Product Change Notification: E-20-007322

PCN Date: 08-JUN-20

RJ45 CONNECTOR CAT6A, IP20 PLUG & VARIANT 14; METAL PLUG, RJ45,CAT6A,8POS.

Terminal Housing for Common core Before Change

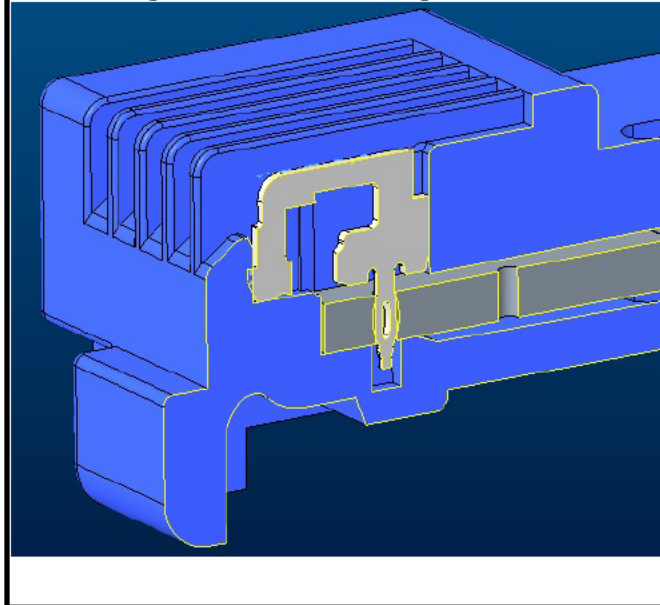
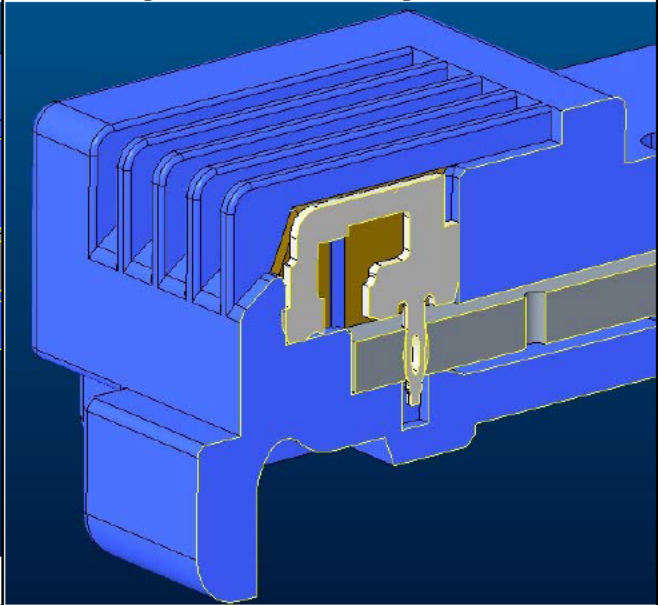
Plastic material will be added to the inner sides of the eight contact chambers within the Terminal Housing to support a smoothly filling of chamber walls and their stabilization. The dimensions acc. to the IEC standard are stronger supported. After a release, please expect a mix of connectors. The new and old design does not have any impact on the functionality. Please note that there will be no physical change on following products except revision letter change: PN 2120864-1, 2-2120864-1, 3-2120864-1, 4-2120864-1 and 2120875-1, 2-2120875-1, 3-2120875-1, 4-2120875-1, 5-2120875-1, 6-2120875-1, 7-2120875-1, 8-2120875-1.
